SECTION 73 • DESIGN STATEMENT

December 2015

PARKER TOWER • PARKER STREET • COVENT GARDEN

Illustration showing the extent of structure to be removed behind the facade.

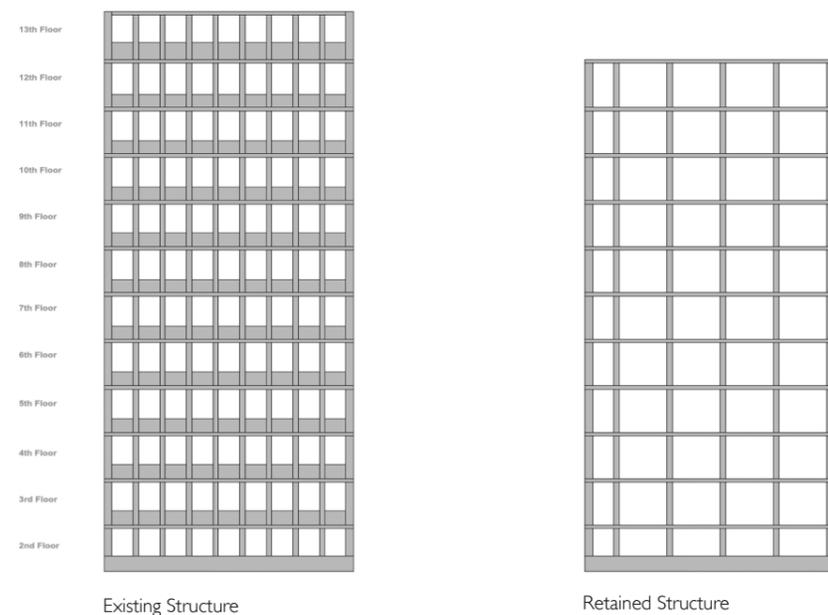
The approved design relies on the adaptation of the existing concrete structural frame, behind the external cladding, removing every other column and the upstand concrete beams around the perimeter of the building, at every floor level, down to level three.

The external concrete frame extends from second floor level to the top of the tower, supported by a large concrete transfer ring beam at second floor level. This ring beam is itself supported on six large columns, allowing lightweight or glazed infill below. The transfer ring beam is a key part of the structure and cannot be cut out to provide space for any form of balcony, being 900mm above second floor level.

The stability of the building is considerably reduced by removing these concrete elements and needs to be replaced with a continuous steel channel around the perimeter of each floor, to reinforce the slab edge, together with the remaining columns bolstered by enlargement with additional concrete additions.

Illustration showing the extent of cut into the floor slab for the approved balconies.

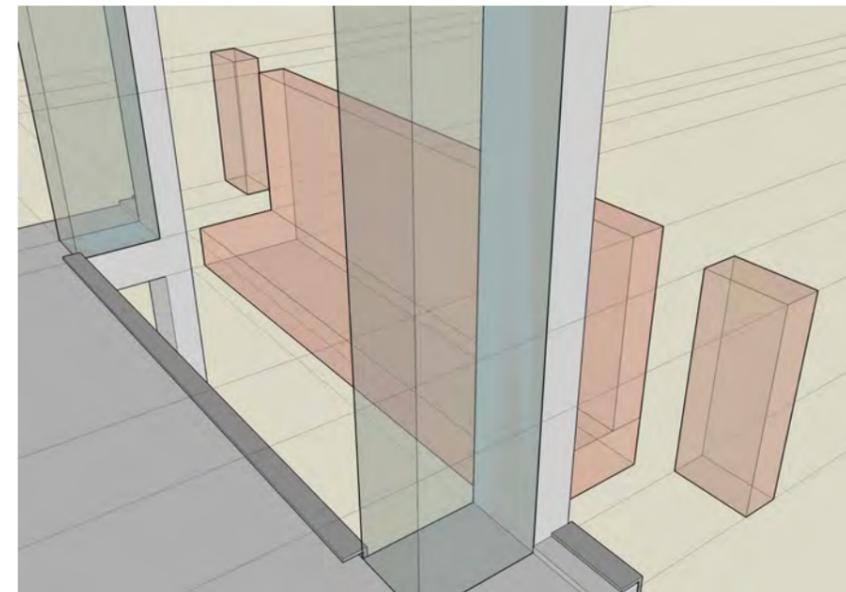
The approved balconies are located at the four extreme corners of the block, inset into the floor plate. Cutting into the floor plate to form recesses for the approved balconies destroys the integrity of the structural approach described above (known as a Vierendeel action), necessitating far greater structural intervention than was envisaged within the approved proposals.

With the cut out of the floor plate to create the proposed balcony, the Vierendeel structure requires additional compensation particularly in the impact on the transfer ring beam, which supports all the upper floors. Additional columns to support the ring beam would be required together with significant strengthening of the transfer beam itself. This would severely stunt the appearance of the building, removing the elegance of the six supporting columns, the cantilever effect and a light glazed infill below.

The cut into the existing floor slabs adds considerable extra demolition works, together with temporary support to maintain stability of the tower and a prolongation of the disturbance from noise and dust to local offices and residents.

Illustration showing the alternative balcony maintaining structural integrity.

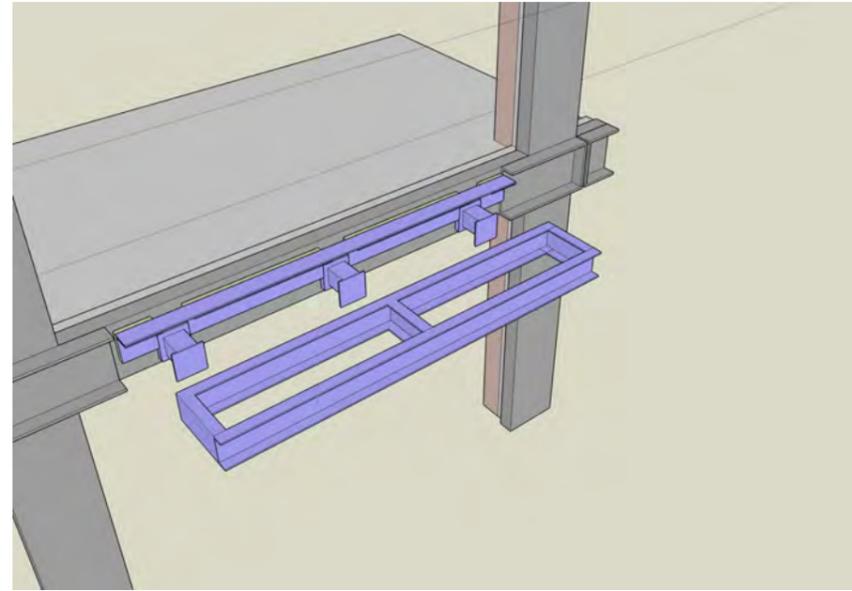
As an alternative, therefore, the design team have looked at adding a slightly reduced depth balcony and incorporating it into the layout of the individual apartments to beneficial effect. By maintaining the existing floor slab line with edge reinforcement by a steel channel, any additional columns and excessive strengthening of the ring beam are avoided.

The revised balcony is the same width as before, but has a reduced the depth from 920 to 570mm, providing an external space of 1.25 square metres. This obviously has an impact on the external amenity area, but by utilizing sliding folding doors, that allow the full width of the balcony to be open, the balcony becomes an extension to the living space, providing a more practical use of the external amenity by not restricting furniture to fit on the separated 900mm deep balcony, that cuts into the room and reduces available internal space.

Typical upper floor plate with proposed balconies

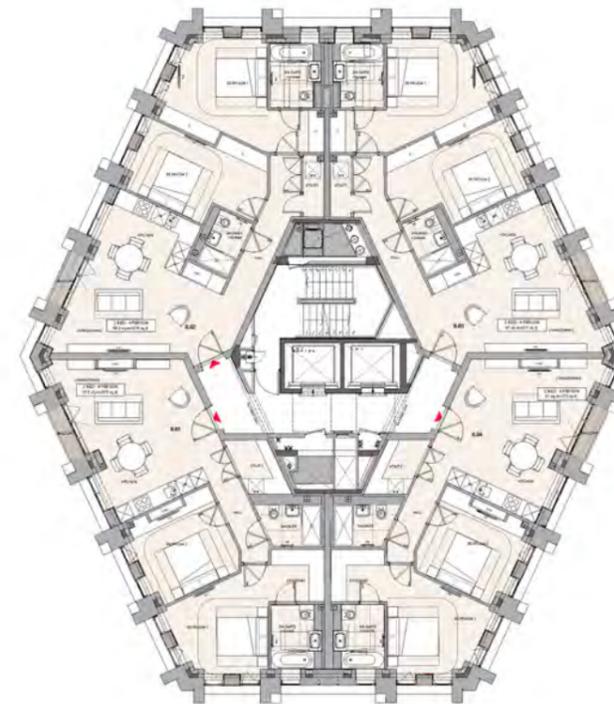
As part of this process, the location of the balconies has also been reviewed to ensure the maximum use and orientation. Two of the approved balconies face entirely north and many of them are located off bedrooms (9), which are unlikely to fulfil their intended function. Six floors currently have no balcony in the northeast corner, due to the proximity of the neighbouring residential block and issues of privacy.

With the reduced balcony footprint, privacy is less of an issue as the occupants are encouraged to use their living space as part of the balcony facility, thus space as a sitting area. The relocated balcony positions keep away from the adjacent residential development, further aiding privacy.

Basement Affordable Block

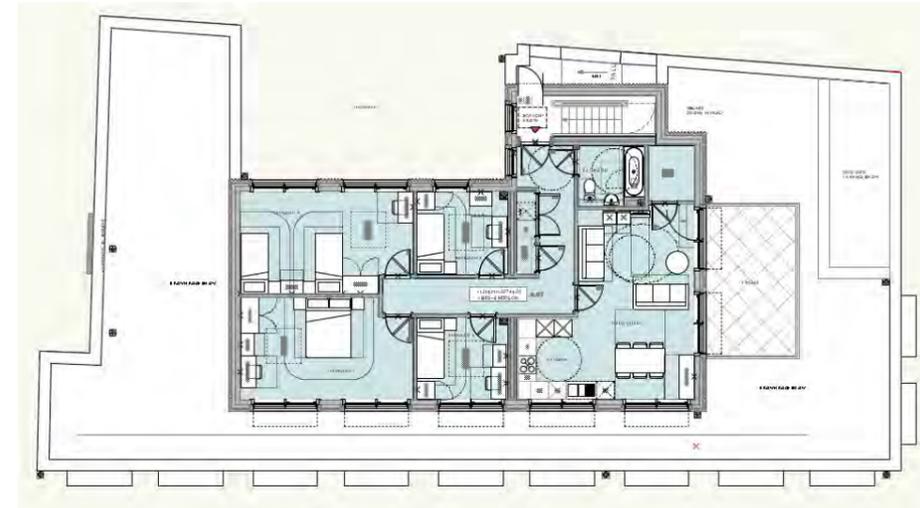
The existing structure and foundations do not lend themselves to this proposal without considerable change in levels, which would elevate the ground floor and extensive new foundations and basement retaining structures, which would have a significant impact on the neighbours.

It is therefore proposed to utilise the existing foundations as much as possible, retaining all the existing boundary retaining walls and use lightweight construction above the ground floor. This necessitates a reworking of the lower floor of the duplex units, retaining existing column positions, with a new transfer structure at ground floor level. Thereafter the upper floors are constructed using a timber frame technique, retaining the original proposal of a brick façade outer facing.

The basement level has been reworked appropriately to accommodate existing column positions, with more detailed layouts developed for the upper units.
